STATE OF NORTH CAROLINA  
DEPARTMENT OF TRANSPORTATION

Subject: **Request for Individual Permit Modification** for NC 16 from north of NC 73 in Lincoln County to North of SR 1386 (St. James Church Road) in Lincoln County. Federal Aid Project No. STP-F-24-1(34) State Project No. 8.1830501. \$475.00 Debit work order 34383.1.4. TIP Project No. R-2206B.

Reference: USACE Individual Permit dated October 7, 2004, Action ID 200420899. NCDWQ Water Quality Certification dated September 21, 2004, Individual WQC No. 3476.

**PLAN VIEW  
SITE 14B**

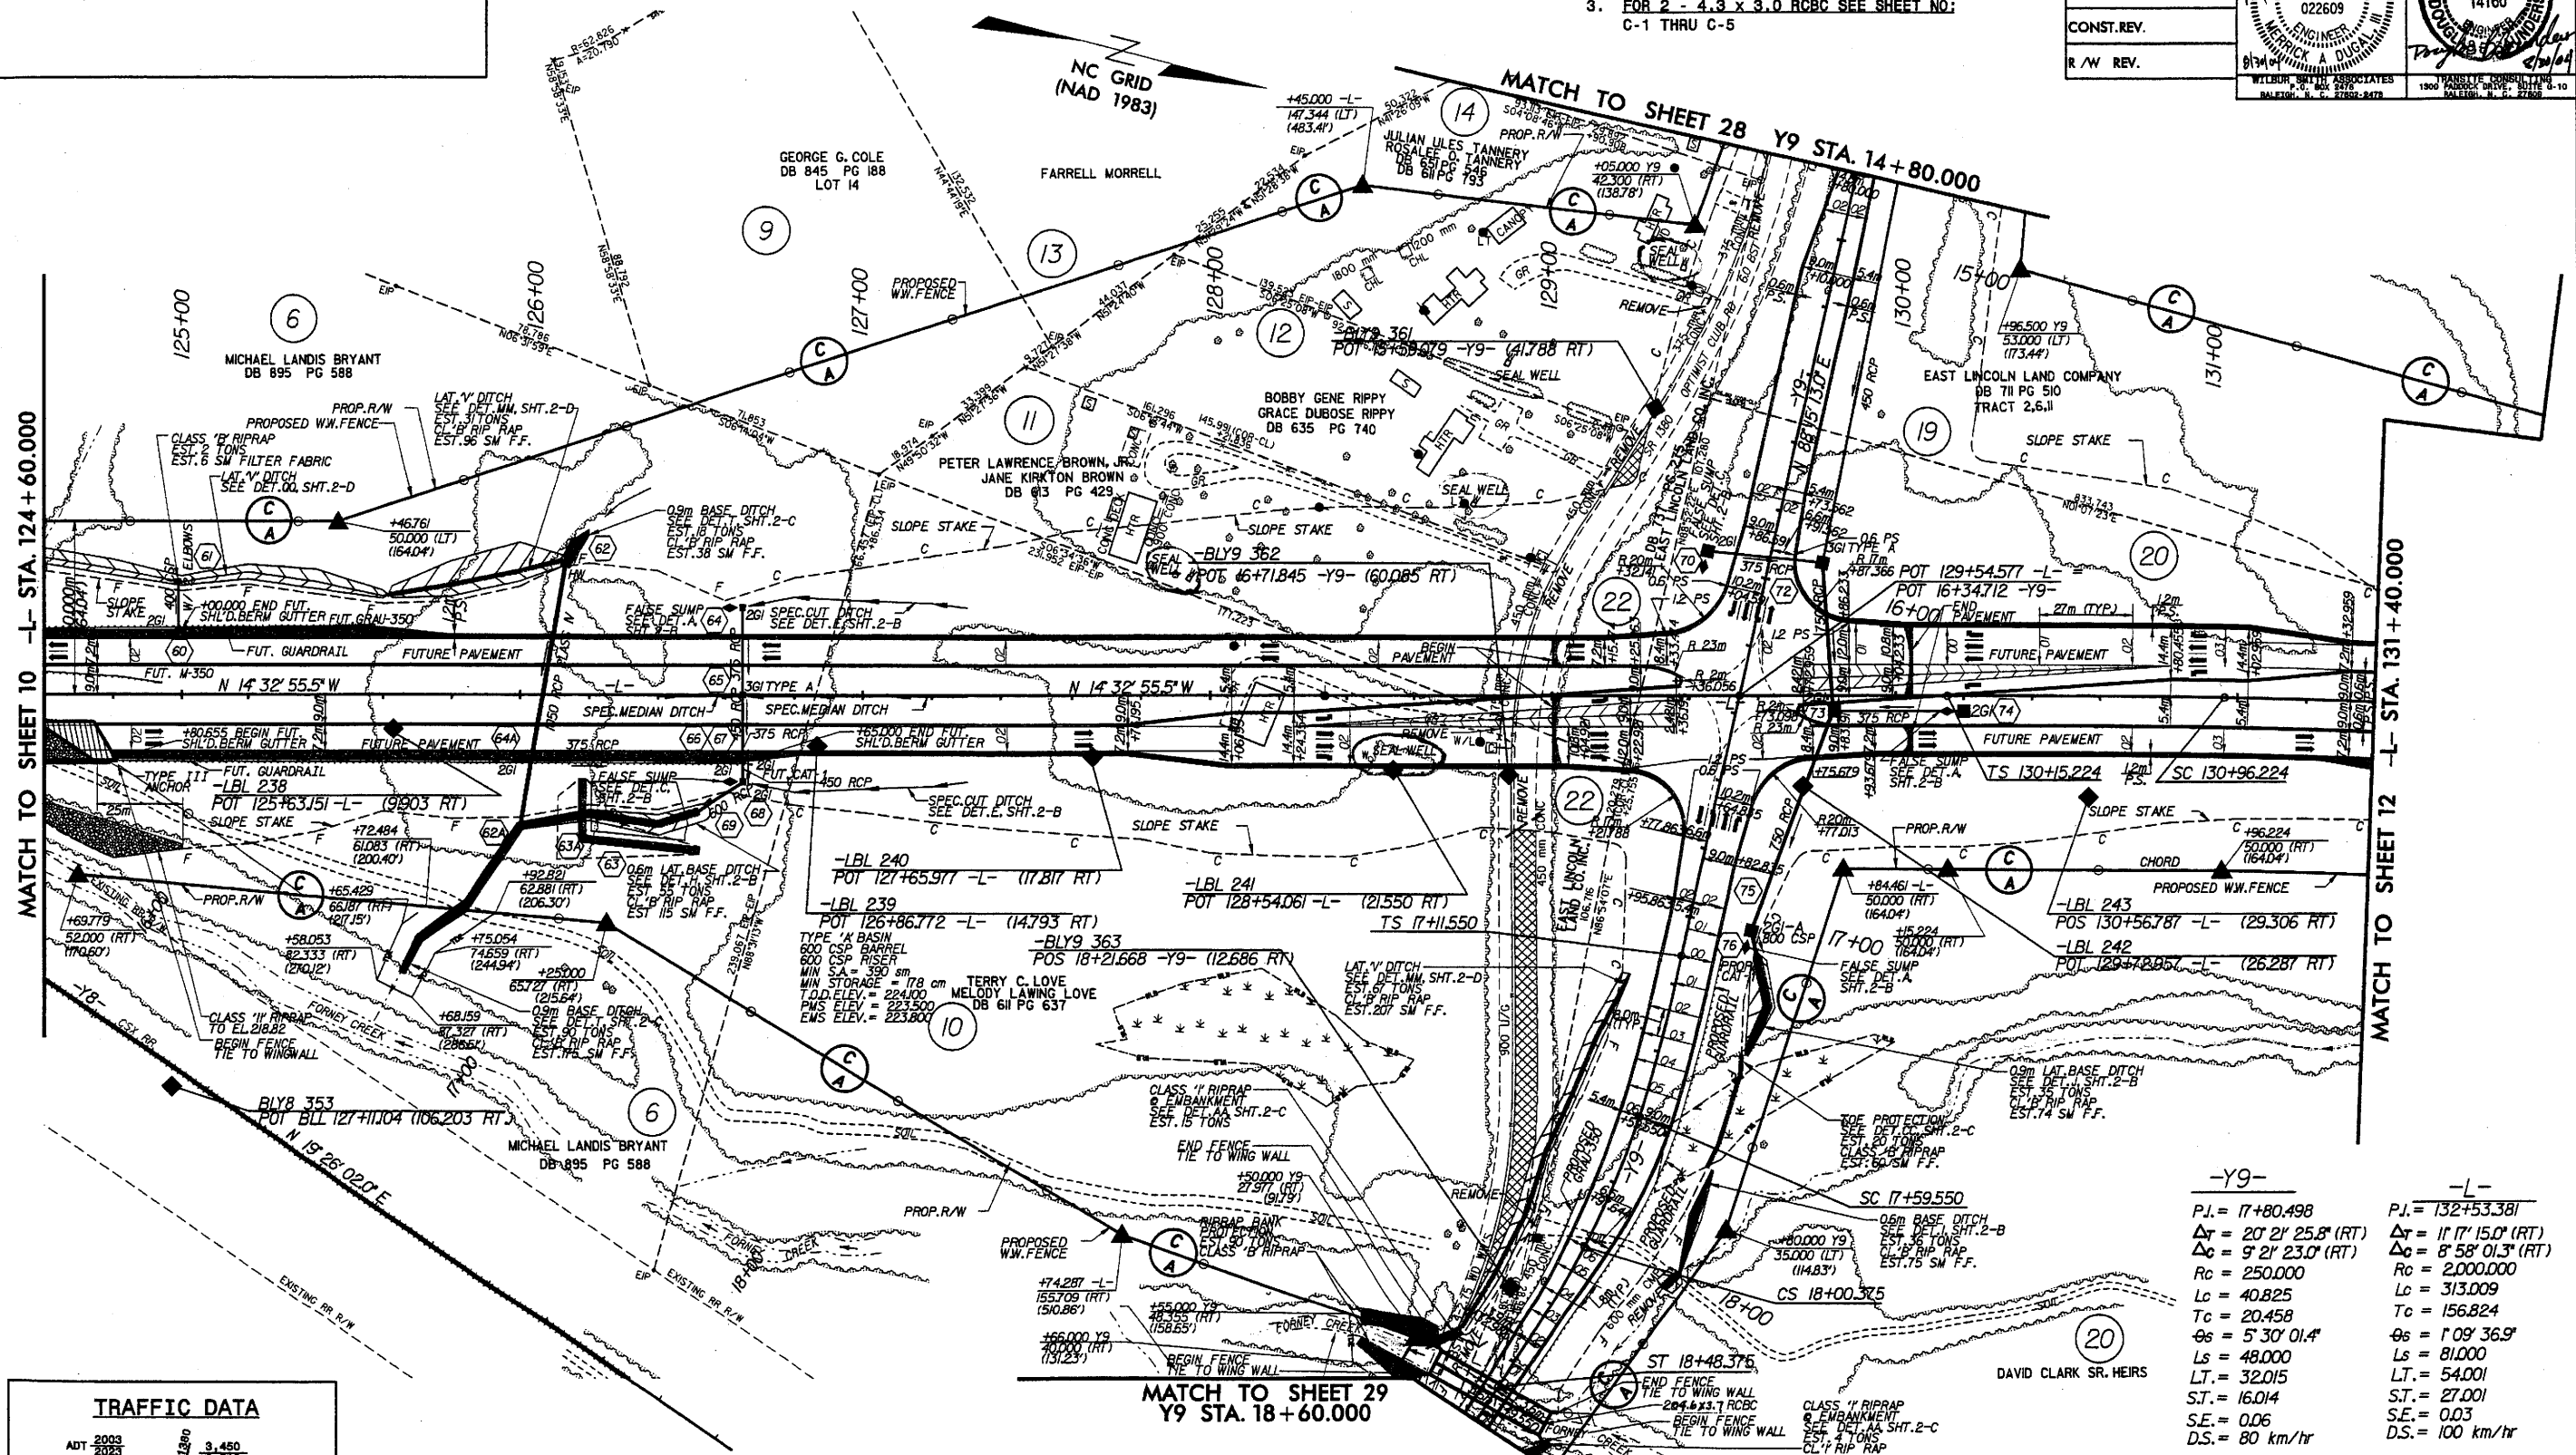
Permit Site 14B is a double barrel box culvert on Forney Creek. A small, unnamed tributary intersects Forney Creek approximately 25 feet upstream of the wingwall for the culvert. The banks of the unnamed tributary were armored with riprap keyed in from the toe of the stream bank to the average high water mark approximately two feet above the surface of the water. This is an after the fact notification. Action was taken to prevent the stream from migrating downstream and discharging into the wingwall of the box culvert. The amount of permanent channel impacted is 75 feet.

# PLAN VIEW SITE 4B

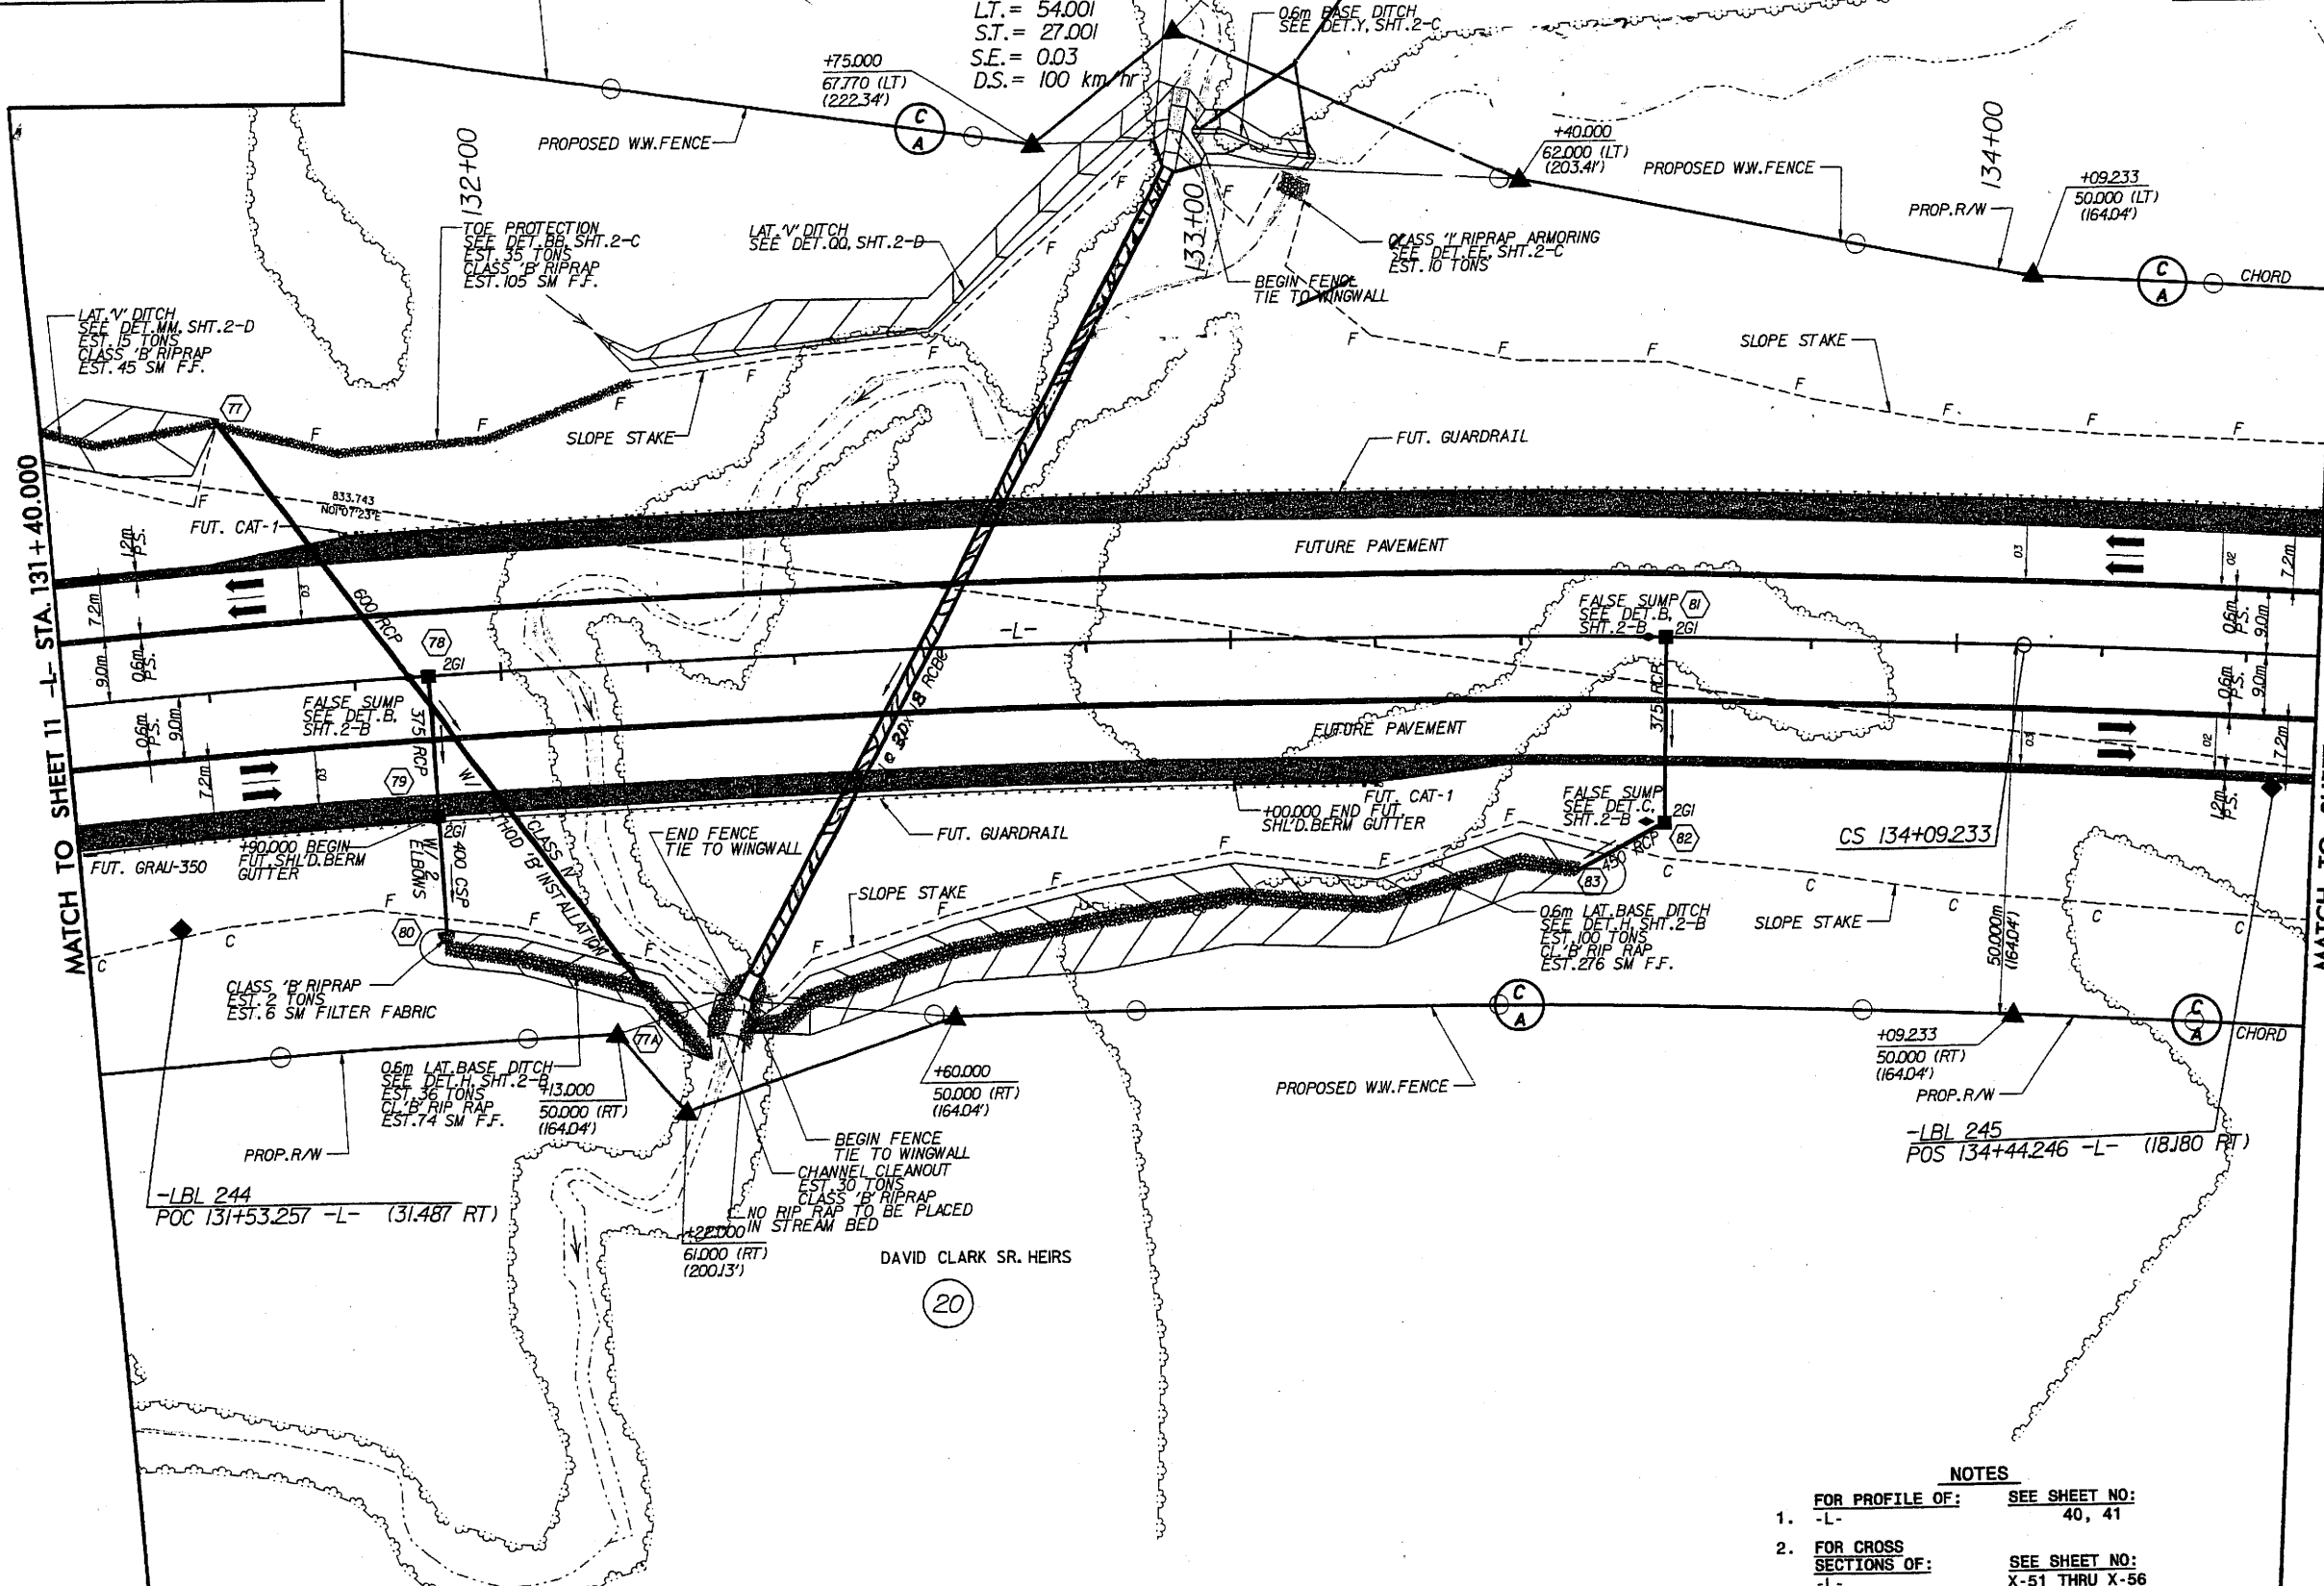
Permit Site 4B is a single barrel box culvert on a UT to Forney Creek. Due to the low flow and low bed load carrying capacity of the subject stream, a 12-16 inch head cut has developed and is moving upstream. A smaller UT intersects the subject stream at the head cut and has developed its own head cut. NCDOT proposes to place a cross-vane weir on the main stem and a boulder in the smaller UT. These measures are proposed to act as grade control and allow aquatic passage.
